**Panel Report**

**Surf Coast Planning Scheme Amendment C114**

**Spring Creek Precinct Structure Plan**

**23 January 2017**

Figure 4 PSP Plan 7 – Road network, public transport and trail

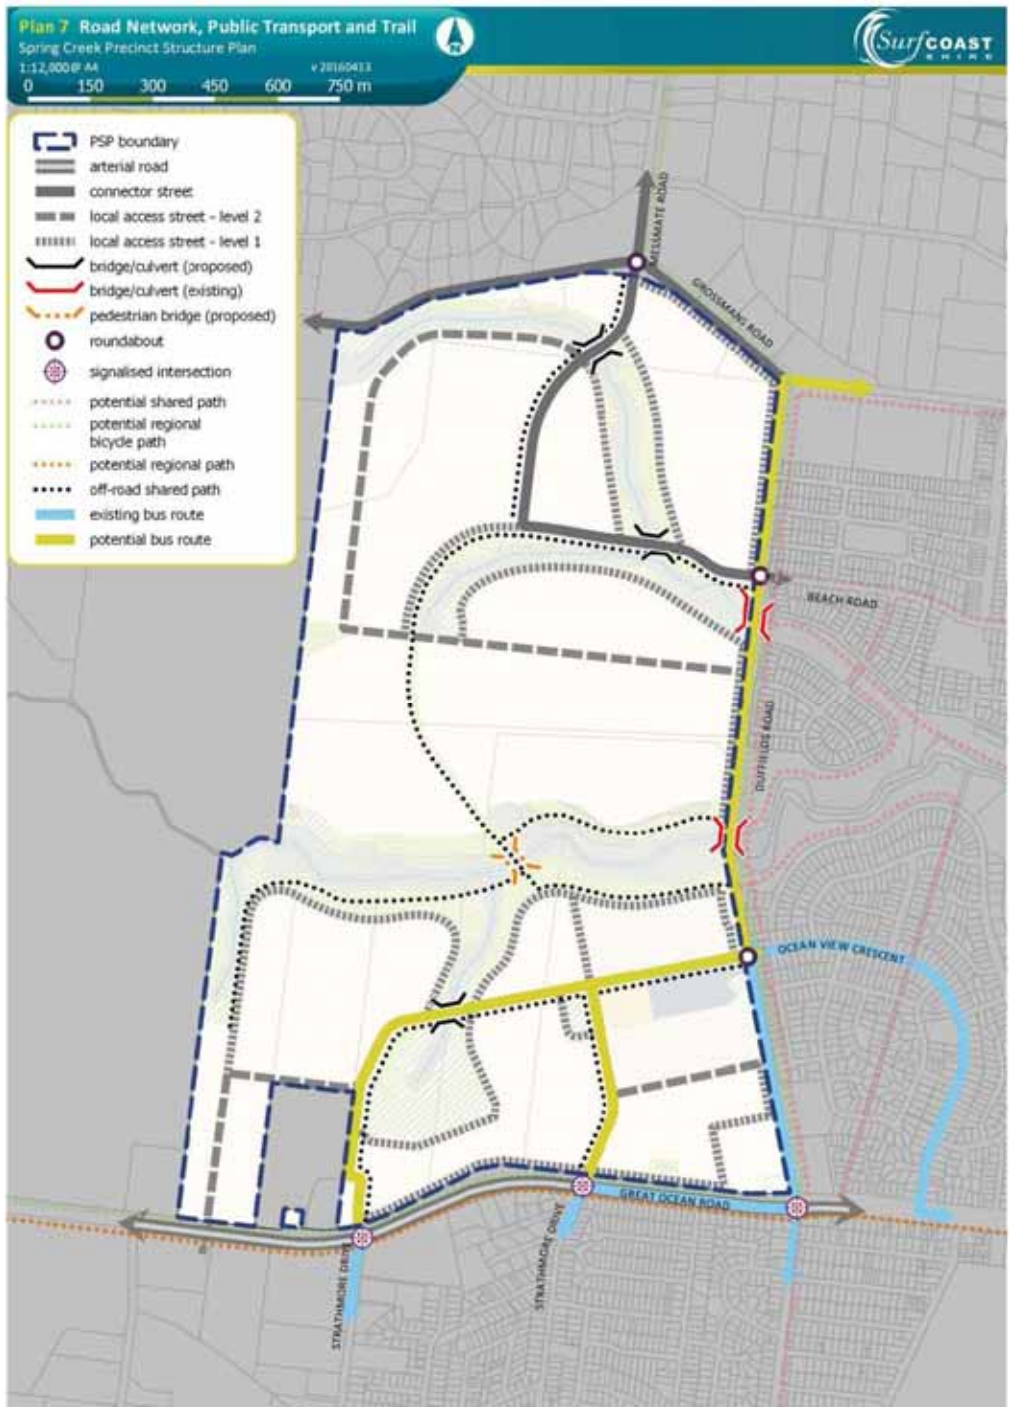
The primary issue with respect to the road network as show in Plan 7 is the exhibited PSP is the number of proposed signalised intersections on the Great Ocean Road.

There are a number of consequential issues if, as required by VicRoads, the signals at the intersection of the Great Ocean Road and Strathmore Drive East are deleted. These consequential issues include:

6. Should the review confirm the decision to replace the signalisation of the intersection with un-signalised staggered T-intersections, the Precinct Structure Plan Plan 7 (Road Network, Public Transport and Trail) be amended as follows:

- a) show a re-aligned north south access street to create a T-intersection with the Great Ocean Road approximately midway between Strathmore Drive East and Torquay Boulevard

- b) change the designation of the north south access street from Connector Street to Local Access Street – Level 2
  - c) include an additional connection from the north south access street to Duffields Road south of Ocean View Crescent subject to resolution of the environmental and sight distance issues raised by Council.

Figure 8 Native Vegetation Precinct Plan – Map 2 Native vegetation to be retained and removed

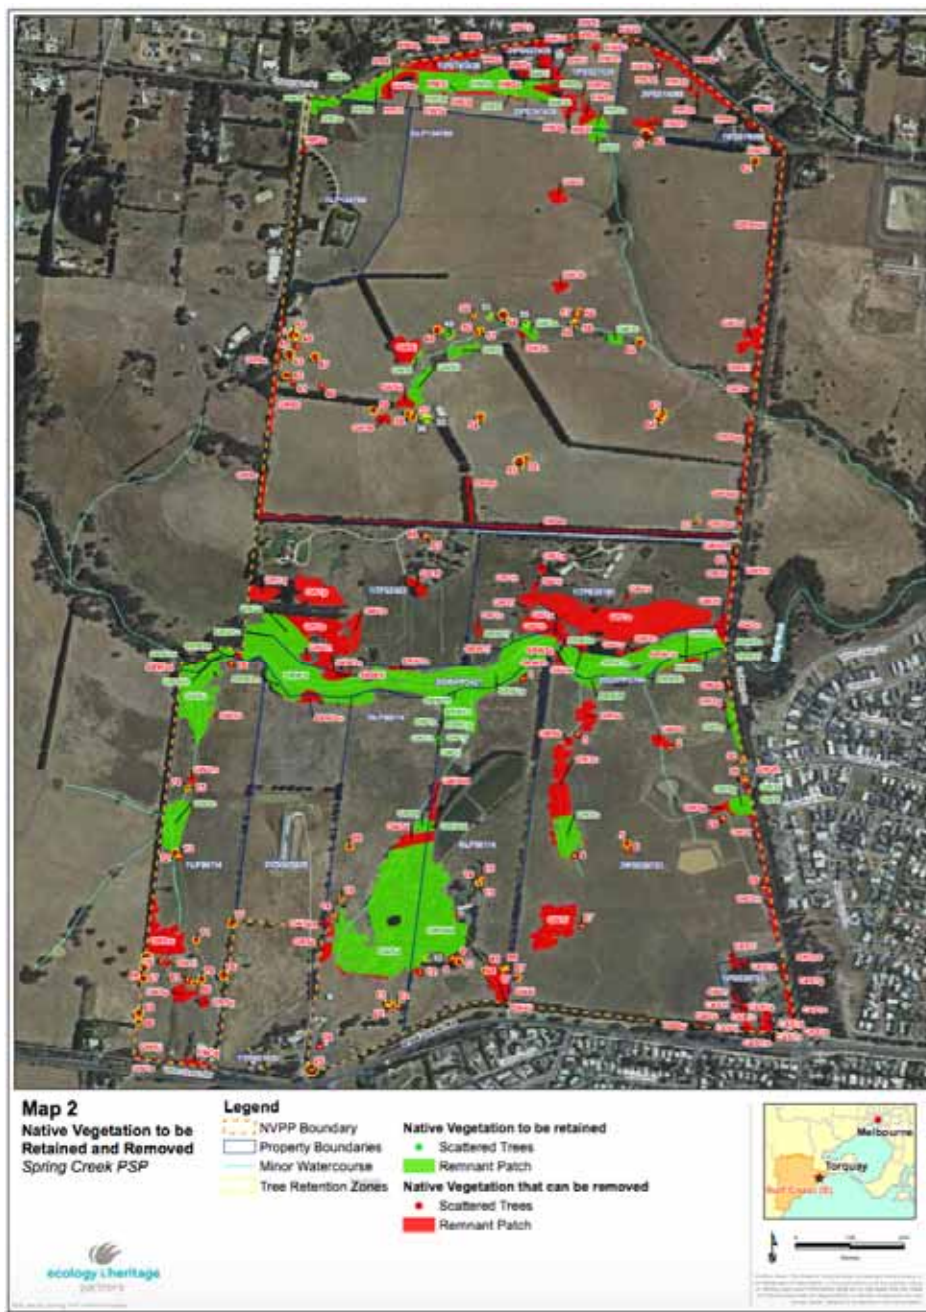
Council submitted that the NVPP sets out the native vegetation to be removed and retained (see Figure 8 below), and it considers native vegetation for practical retention. This process is undertaken on the principles of avoid and minimise losses of remnant vegetation.

13. Amend the wording of R23 of the Precinct Structure Plan to allow for a permit application to remove native vegetation identified for protection in the Native Vegetation Precinct Plan.
14. Council consider using the best part of GW5 as a net gain native vegetation offset, with consideration of appropriate public access that manages identified threats and protects the values of the biodiversity asset.
15. Remove SRW1 from the Precinct Structure Plan and Native Vegetation Precinct Plan as vegetation proposed for retention in a conservation reserve.
16. Review the status of native vegetation at 160 and 195 Grossmans Road, and amend the Biodiversity Assessment and Native Vegetation Precinct Plan accordingly.

Figure 9 PSP Plan 6 - Open Space and Community Facilities Plan

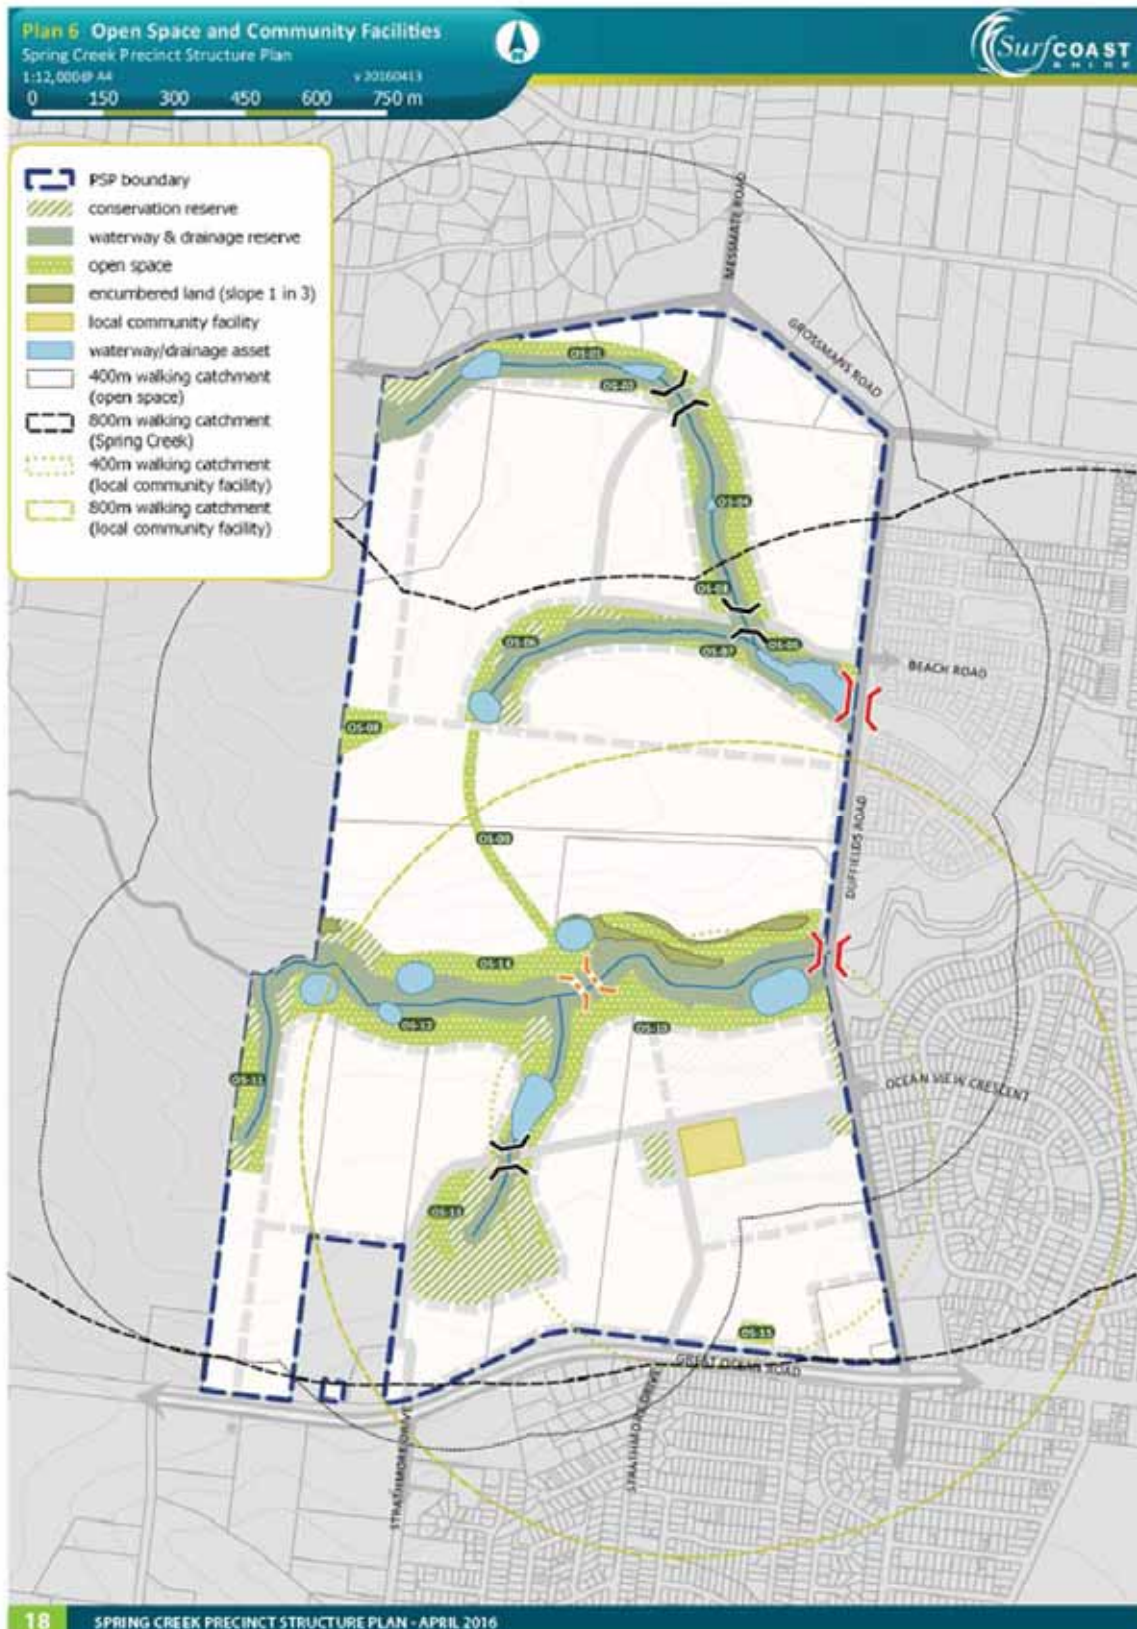
Council submitted that *“the precinct’s location within the Spring Creek valley provides an ideal opportunity for the provision of open space and an open space network”*. Figure 9 shows the location and distribution of proposed open space in the exhibited Spring Creek PSP.

Council commissioned ASR Research to prepare a Community Infrastructure Assessment (CIA) for the site which included recommendations relating to open space provision.

Figure 10 Alternate Draft Framework Plan  
Source: Mack submission (submitter 43), Appendix F

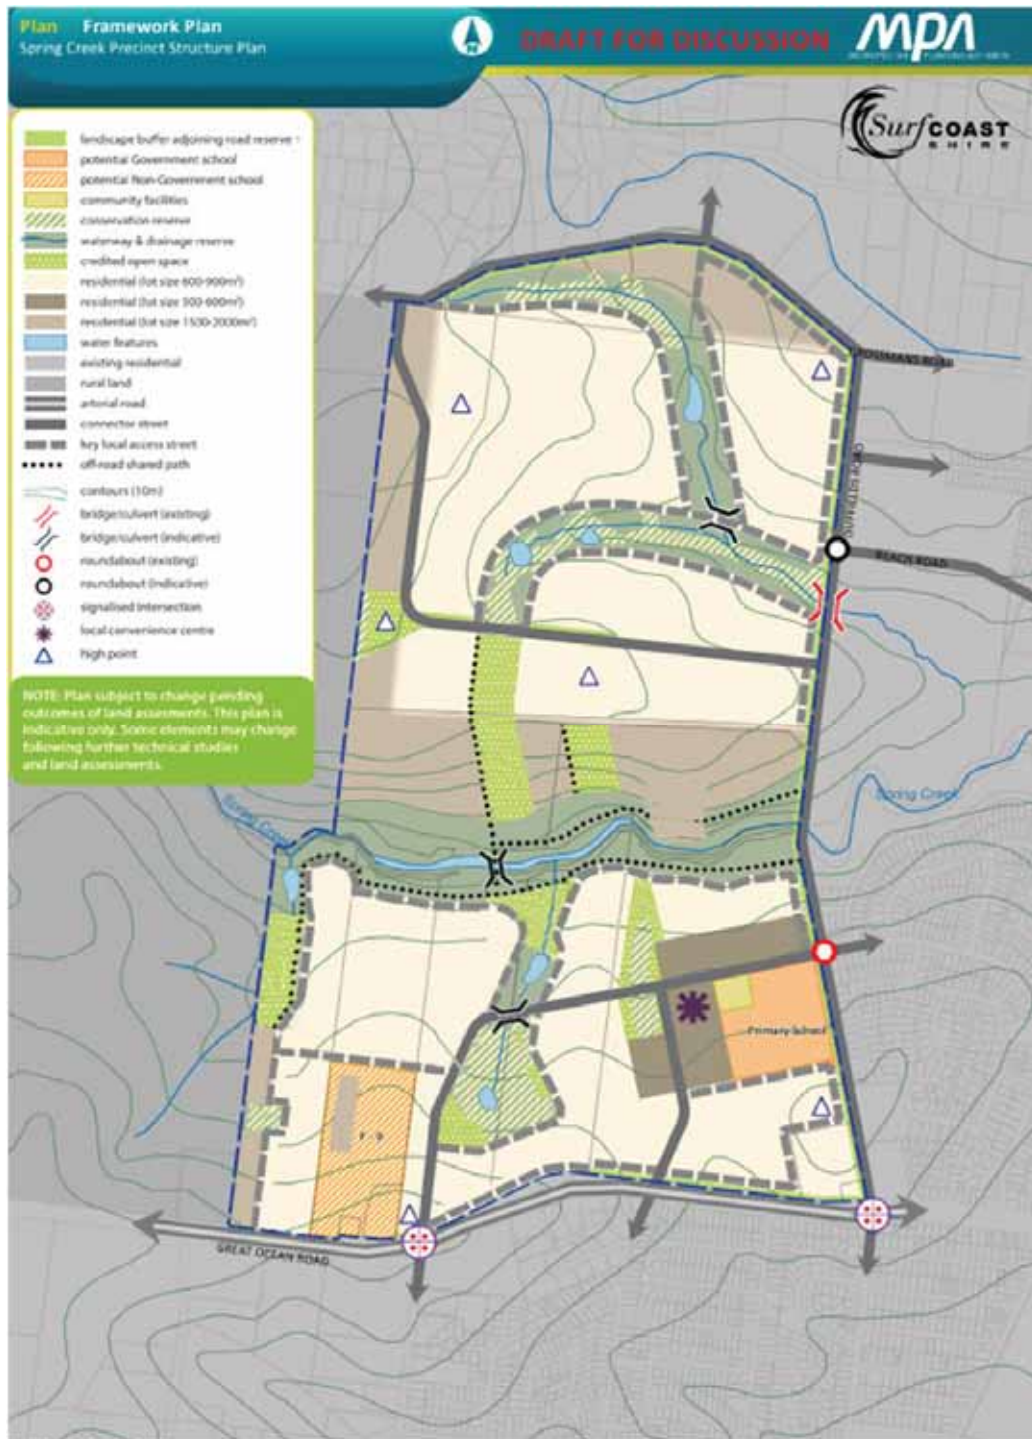
Mr Harvey gave evidence that it would appear that 200 – 220 Great Ocean Road had been disproportionately allocated larger areas of retained native vegetation (GW5) relative to other properties across the PSP (34 percent of total retained vegetation within the PSP), and that the alternative draft Framework Plan prepared by Niche Planning (see Figure 10) sets out a more appropriate and equitable distribution of conservation reserves.

Mr Harvey gave evidence that alternative Framework Plan focused on protecting the core of the patch and removing the requirement to retain the lower quality portion of the patch in the south west.

Figure 14 Plan 5 Spring Creek PSP

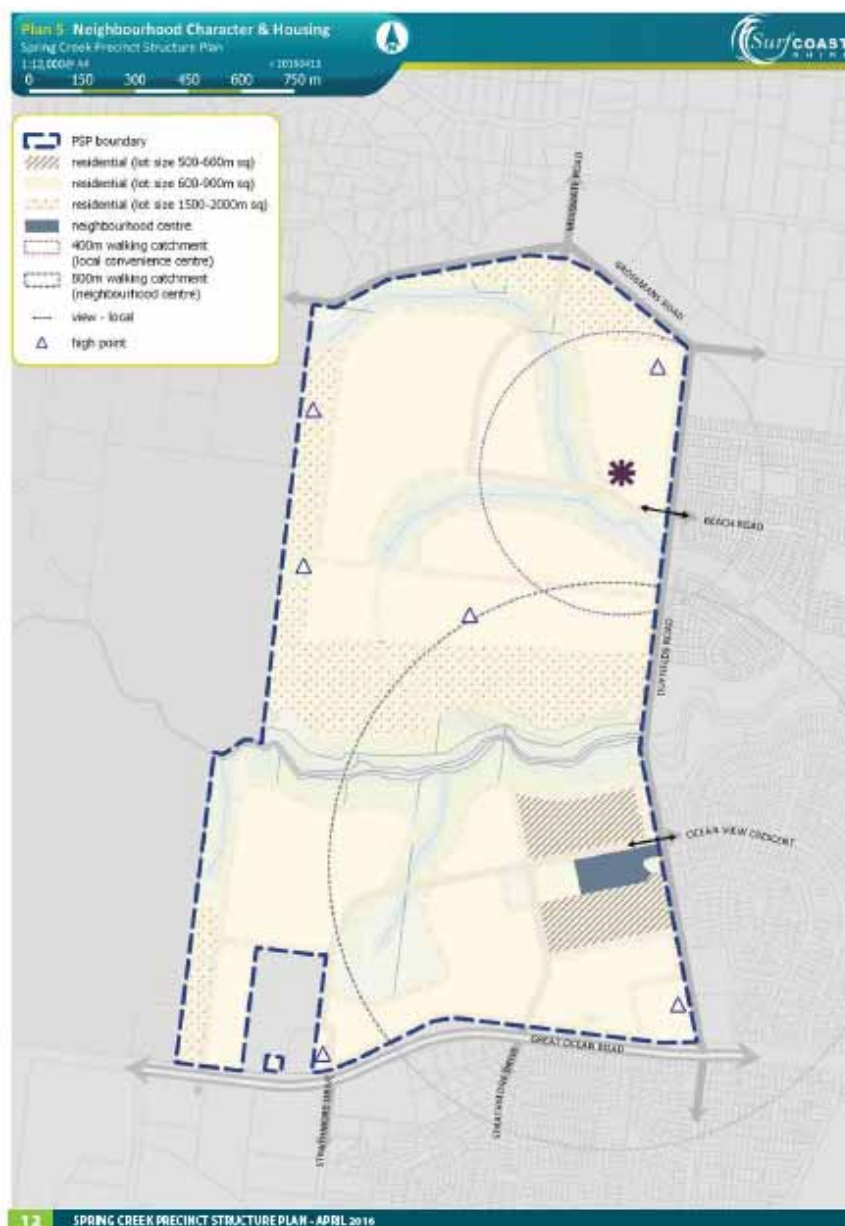
Council submitted that the PSP at pages 12 and 14, Plan 5 and Table 2 sets out the location of the various lot sizes. The PSP envisages an average density of 10 dwellings per net development hectare.

Council submitted that the Planning Scheme specifically states that lower densities should be provided in Spring Creek. The PSP achieves the objectives for this development area notwithstanding the lower density. Council opined:

29. Reinststate the asterix on Map 1 of the Urban Growth Zone and Plan 5 of the Precinct Structure Plan denoting a Local Convenience Centre in the northern precinct.
